UNITED STATES PATENT AND TRADEMARK OFFICE

APPLICATION NO.	FILING DATE	FIRST NAMED INVENTOR	ATTORNEY DOCKET NO.	CONFIRMATION NO.
10/791,778	03/04/2004	Chin Sung Ko	MR1197-610	4406
4586	7590	03/30/2006	EXAMINER	
ROSENBERG, KLEIN & LEE 3458 ELLICOTT CENTER DRIVE-SUITE 101 ELLIOTT CITY, MD 21043			HAWK, NOAH CHANDLER	
			ART UNIT	PAPER NUMBER
			3637	
DATE MAILED: 03/30/2006

Office Action Summary	Application No.	Applicant(s)
	10/791,778	KO, CHIN SUNG
	Examiner	Art Unit
	Noah C. Hawk	3637

DETAILED ACTION

Katzberg '003, Figure 2

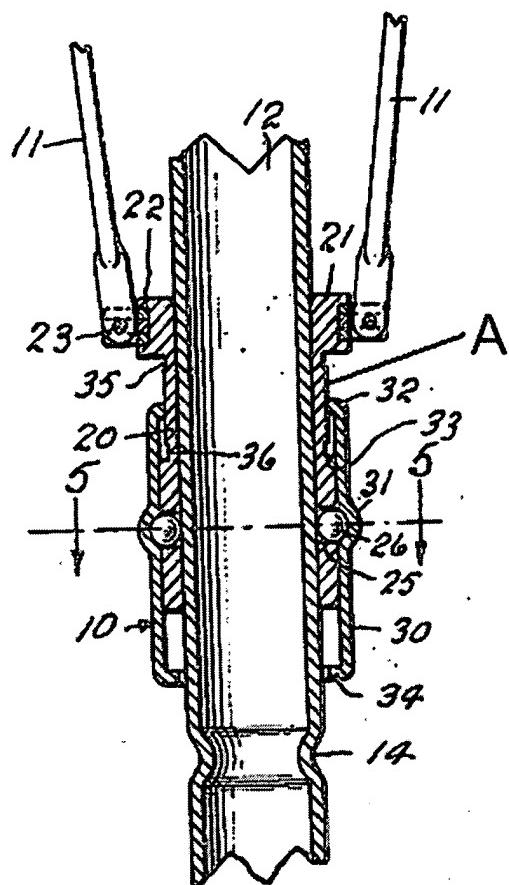
4. Claims 1 and 2 are rejected under 35 U.S.C. 102(b) as being anticipated by Katzberg in US Patent 2528003.

a. Regarding Claim 1, Katzberg discloses an engaging structure for an umbrella including a runner (encompassing 10 and 20) having a plurality of side apertures (25) formed on an inner circumference thereof, said runner having formed on an outer circumference thereof a positioning ring (A, Best seen in Katzberg, Figure 2, below), a plurality of balls (26) each received in a corresponding one of said apertures, a sleeve (30) slidably displaceable on said outer circumference of said runner, said sleeve including an upper opening (the opening at drawing line 5-5 in Figure 2) and an inner middle edge (the edge at drawing line 6-6 in Figure 3) having smaller diameter relative to a diameter of said upper opening, said sleeve having an inner low projective ring (32) formed on an inner circumference thereof so as to be selectively positioned on either of opposing sides of said positioning ring and a shaft (12) received in said inner circumference of said runner and having an annular concave portion (14) for receiving said balls therein, said balls being maintained in said annular concave portion by said middle edge of said sleeve when said projective ring is on a first one of said opposing sides of said positioning ring and said balls are received in said upper opening when said projective ring is on a second one of said opposing sides of said positioning ring.

- b. Regarding Claim 2, Katzberg '003 discloses that the shaft is provided with several grooves (13, 14) spaced apart around the circumference thereof for engaging with said balls.

6. Claim 3 is rejected under 35 U.S.C. 103(a) as being unpatentable over Katzberg '003 as applied to Claim 1 above. As stated above, Katzberg '003 teaches all of the limitations of Claim 1 including an umbrella runner but does not teach the use of two tubes as an engaging means for the balls. However, the two tubes mounted on the shaft in spaced relationship to form an annular recessed portion therebetween are an obvious variation of the single sleeve with an annular concave portion of Katzberg. The use of two tubes in spaced relationship on the shaft serves the same function as the groove taught by Katzberg: an annular concave portion is formed for receiving the balls, retaining the runner. Further, the shape of the annular concave portion formed by two tubes in spaced relationship could be identical to that of a concave groove machined by a lathe into a shaft by a square-ended cutting tool, and the manufacture of a shaft with two tubes in spaced relationship would be easier to accomplish than that of a shaft with an integral groove.
